Enclosure 1
Changes to Hermes 2 PSAR Chapter 7
(Non-Proprietary)

Figure 7.1-1: Instrumentation and Controls System Architect

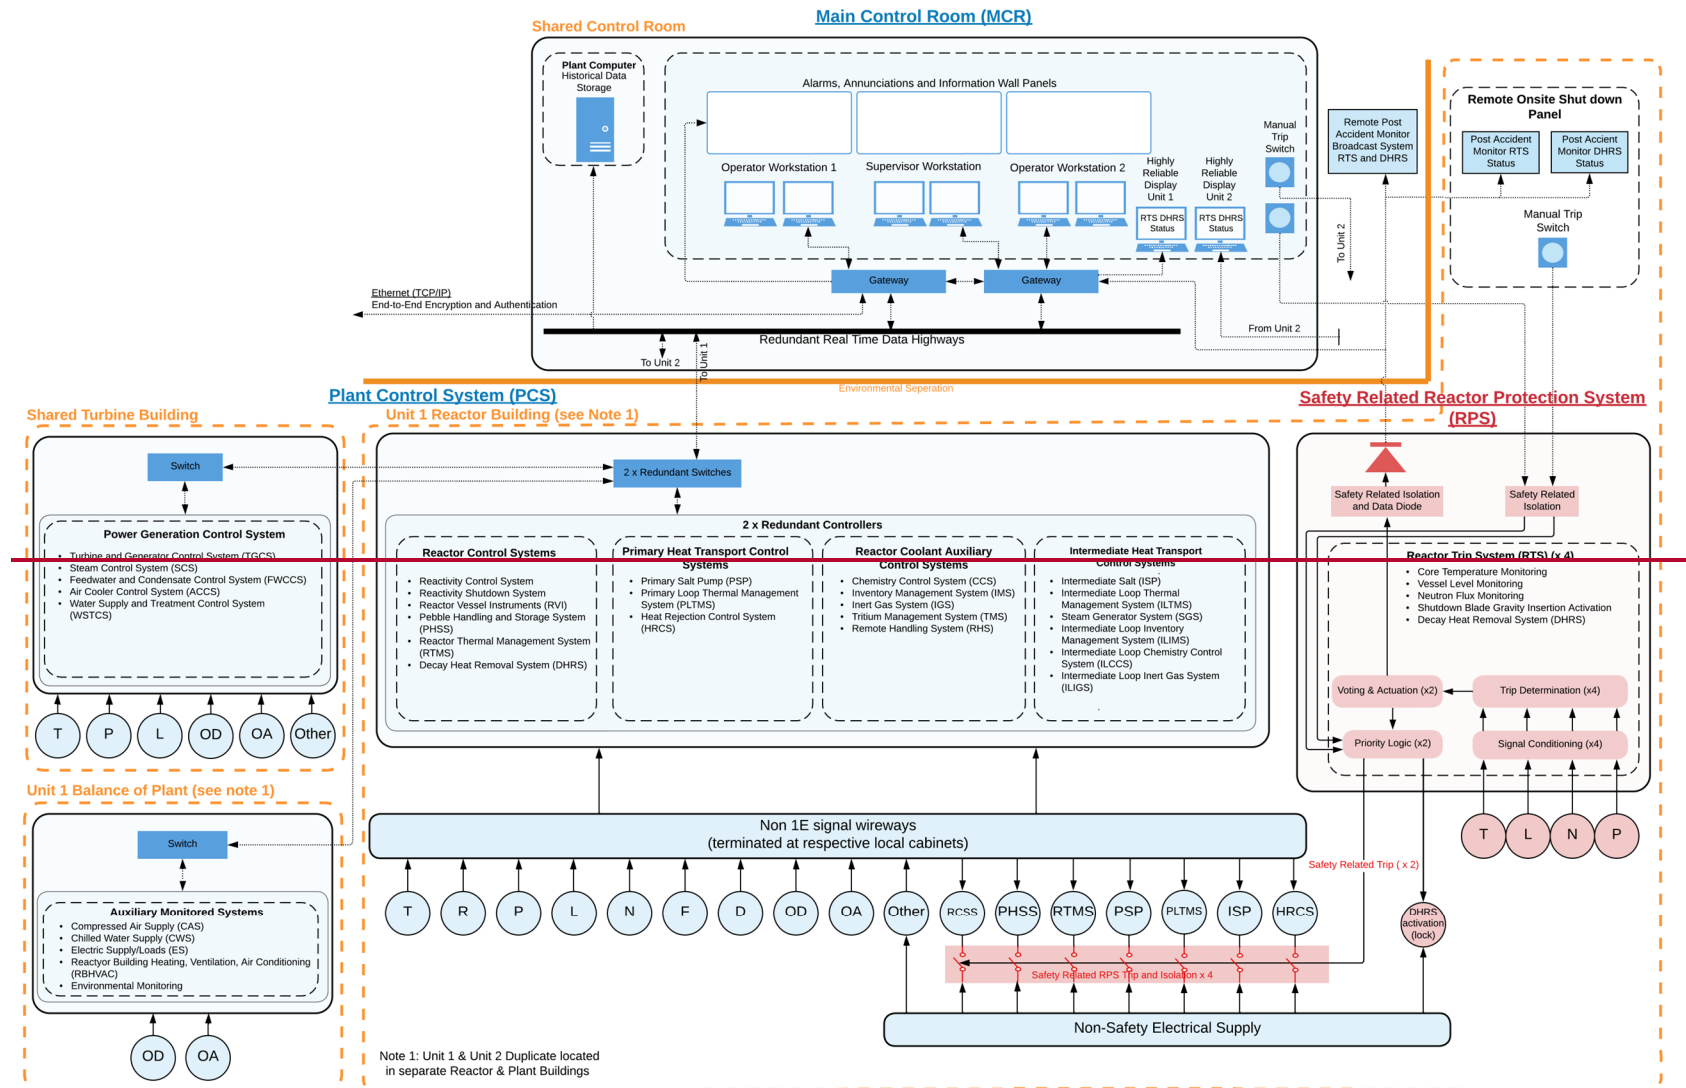
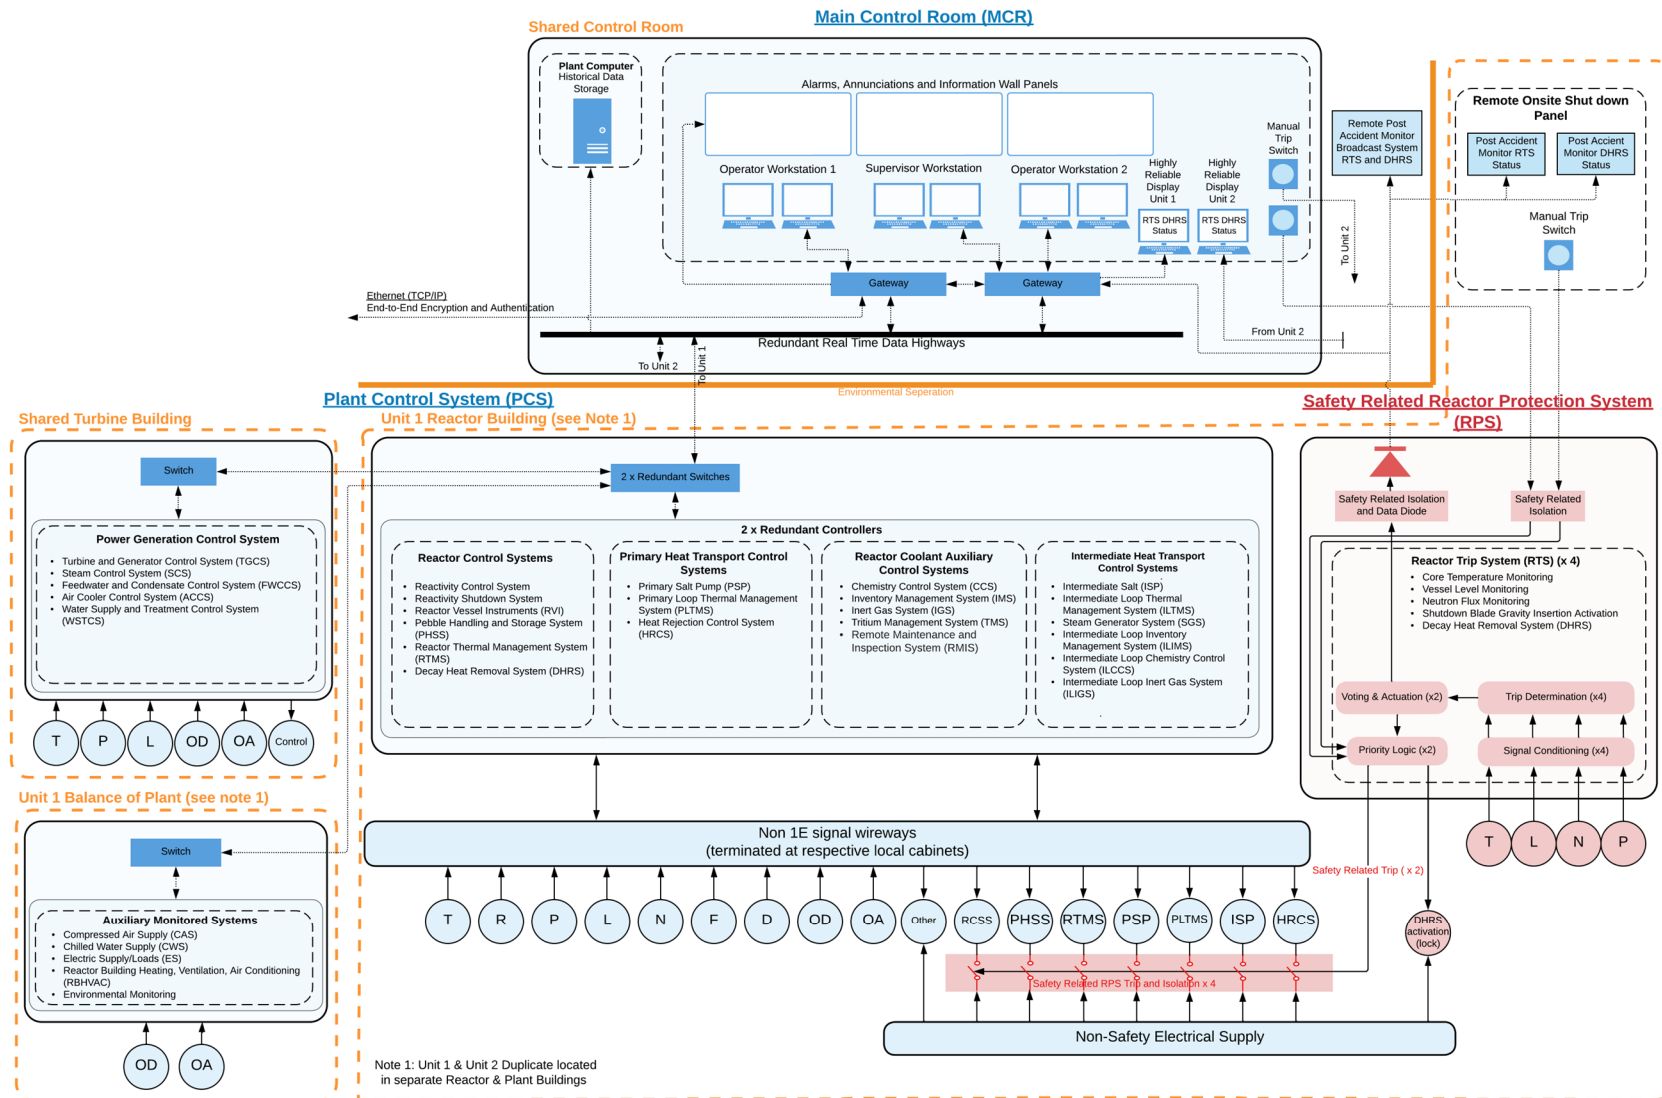
The RCS controls and monitors systems and components that support normal operation, planned transients, and normal shutdown of the reactor. The RCS controls the systems listed in Figure 7.1-1 and supports the following capabilities:

Highlighted text was previously changed.
Submitted on 1-3-24 (ML24003A766).
